**F/YR23/1073/F**

**Land East Of Cirston House, Hockland Road, Tydd St Giles, Cambridgeshire**

**Erect 1 x dwelling (2-storey 3-bed) and garage, involving the demolition of existing stables**

**Officer recommendation: REFUSE**

SITE PLAN 1:500

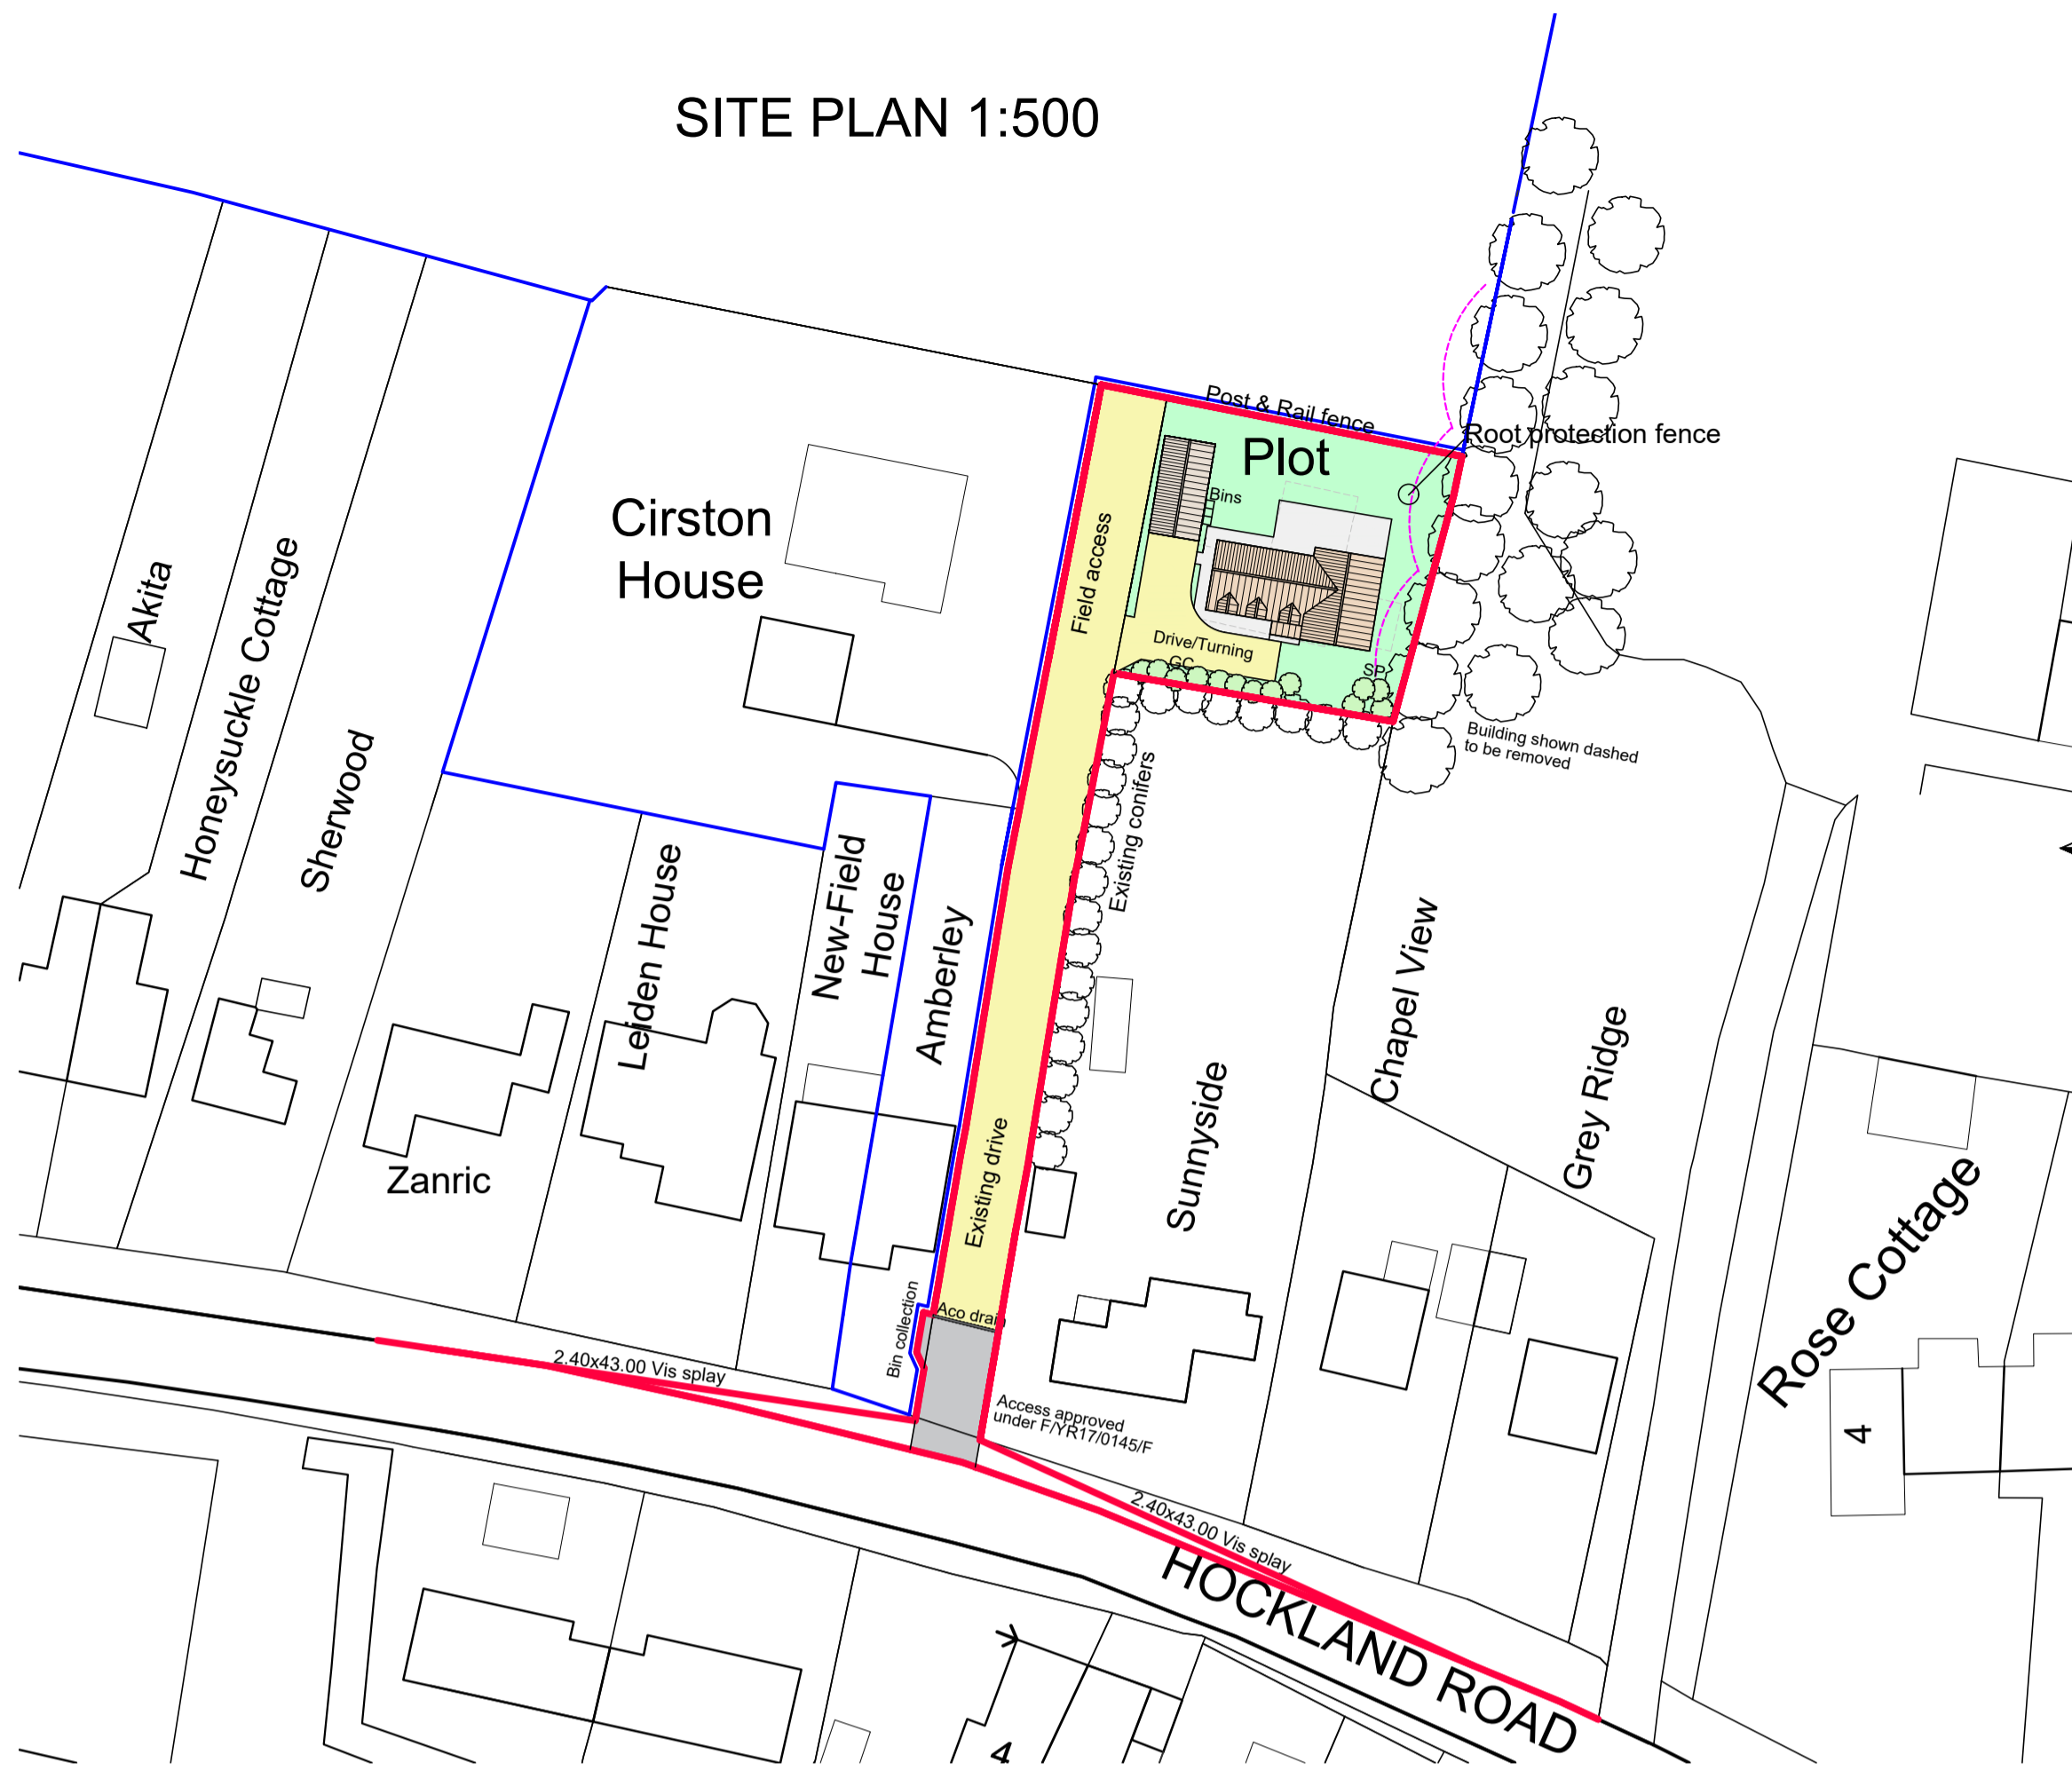
*The proposed development's site access is from Hockland Road. The access appears to have appropriate visibility for the speed limit on Hockland Road linked to access which to scale 5m wide would appear to be appropriate for the shared use private driveway.*

*Ideally, the submitted plans submitted by the applicant should be dimensioned for clarity. That said it appears to be sufficient area set aside within the plot for parking and turning manoeuvres within the site.*

*An ACO drain is shown crossing the driveway, however it is unclear how this relates to the fall of adjacent surfaces. The applicant would be expected to ensure that water from private surfaces do not drain to the adjacent public highway. If the LPA are mindful to approve the application, please append the following Conditions to any consent granted.*

10.27 The submitted plan shows an appropriately sized garage for 1 parking space and sufficient room to the front of the garage for a second parking space. There is an area to the front of the property set for vehicles to be able to turn on site and leave in a forward gear.

10.33 The submitted plans show bin storage for the site located along the private driveway close to the entrance from Hockland Road and to the front of Amberley. This is not considered ideal however it mirrors the arrangements for Cirston House and as such is not considered unacceptable.

*The approved access and all hardstanding within the site shall be constructed with adequate drainage measures to prevent surface water run-off onto the adjacent public highway and retained in perpetuity.*

*Prior to the first occupation of the development the proposed on-site parking/turning area shall be laid out in accordance with the approved plans, surfaced in a bound material and drained within the site. The parking/turning area, surfacing and drainage shall thereafter be retained as such in perpetuity (notwithstanding the provisions of Schedule 2, Part 1, Class F of The Town and Country Planning (General Permitted Development) (England) Order 2015, or any instrument revoking or re-enacting that Order).*
